Seattle Design Commission

MINUTES OF THE MEETING

16 December 2004

Park Site Plan

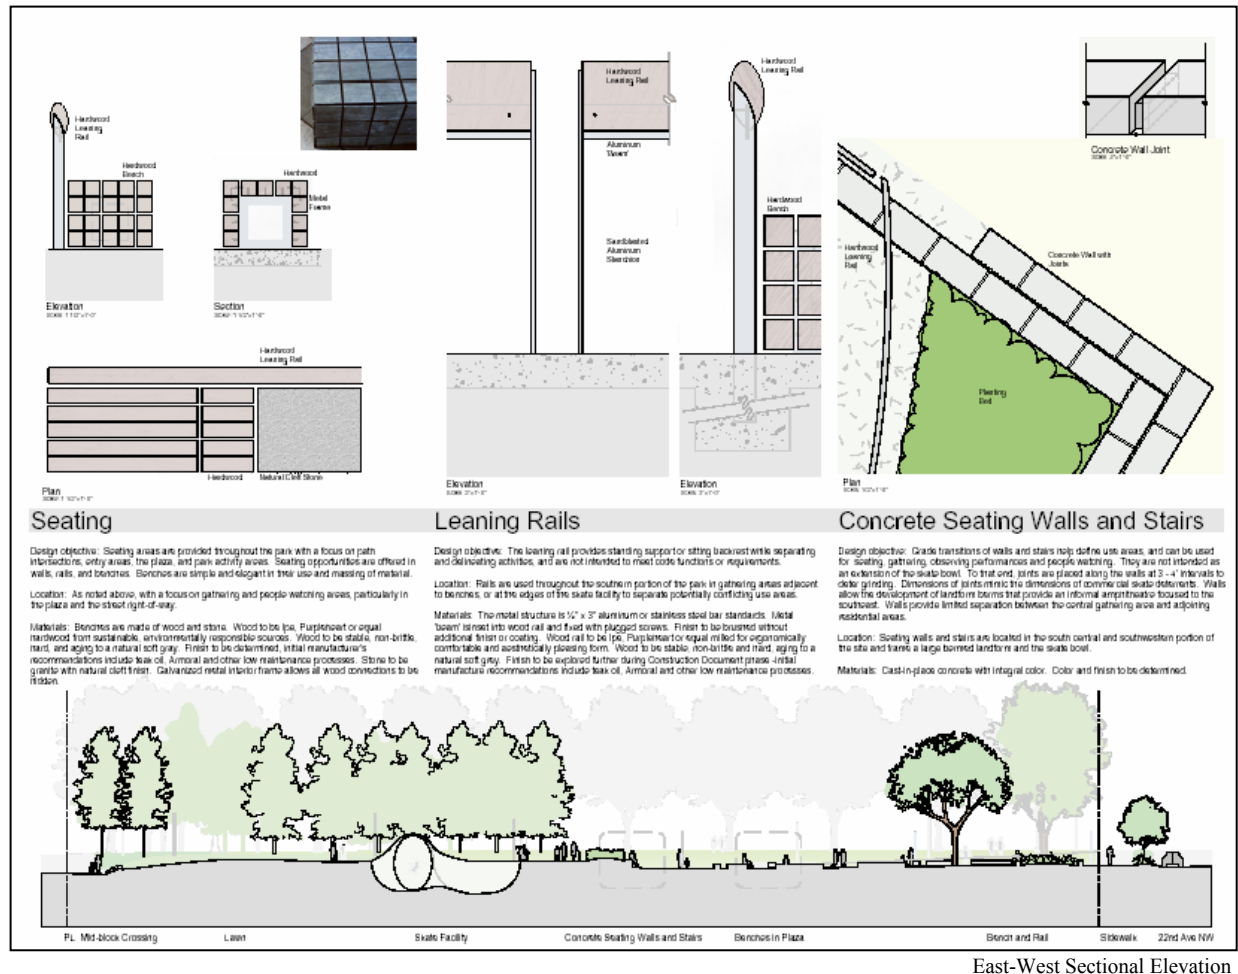
- Concerned that there seems to be a disconnect between the elegance of the plaza and water feature and the energy of the skate bowl;
- Urges proponents to continue to look at the scale of the water feature and its location within the plaza and proximity to the street;

- States that the shape of the skate bowl might integrate better with the sculptural shells that are to be used as art elements in the project, and its geography could tie in better to the sweeping curves that organize the plan;

- Encourages more opportunity to sit and watch the skating, as this will be an attraction for the area;
- States that the amount of grass used in the park design seems excessive, and suggests a focus on a more strategic use of lawn, particularly in considering whether it should be used under the birch trees;

- Urges proponents to look at more urban design opportunities of the birch grove;
- States that the design of the benches needs to be more elegant and functional;

- Urges careful consideration and selection of the big tree, its location within the space, and its proximity to the skate bowl;
- Recommends approval of design development but would like to see the project again in follow-up.

- Asks if children will play in the fountain.
 - Proponents stated that they hope many people will use the water feature.
- States that the design lacks integration of key elements. States that the challenge is in the juxtaposition of the skate bowl and the fountain.
- Asks if there is townhouse access off of the park
 - Proponents stated that the townhome contention is a code issue. Stated that the developer has chosen to build up to the property line, but could have done a setback.
- States that the community representative has some good points in terms of the benches and seating that could be addressed in the design
- States that there needs to be sun in order to appreciate a water feature. Encourages proponents to consider removing some of the surrounding trees. Further encourages a bigger bowl, but a smaller park.

- Encourages proponents to minimize the amount of grass and to include more paving.
- States that the fountain as a play area may not be appropriate. Encourages proponents to reexamine the size of the fountain and its granite blocks, and to consider reexamining its orientation to the street.

- States that the new design gives the feeling of two separate parks.
- States that an explanation is needed to justify the location of the big tree.
- Encourages the artist to reconsider how the edge of the skate bowl might be better integrated with the art form of the sculptural shells.

- Encourages proponents to look at an example of the tight birch grove at Tate Modern.
- States that there should be less grass and more activity areas. Questions the location of the fountain and its proximity to the street, but states that all other elements of the design seem to be in the right place. Encourages a slight tweaking of the design rather than a major shift of elements.

- Proponents stated that the size of the existing bowl is 2,250 square feet, and the size of the new bowl will be 4,000 square feet. Stated that it is impossible to accommodate both street and bowl skating on the current site.

- Proponents stated that granite blocks in the fountain area are only 3 feet high. Stated that there is a need to better integrate the fountain into the site.
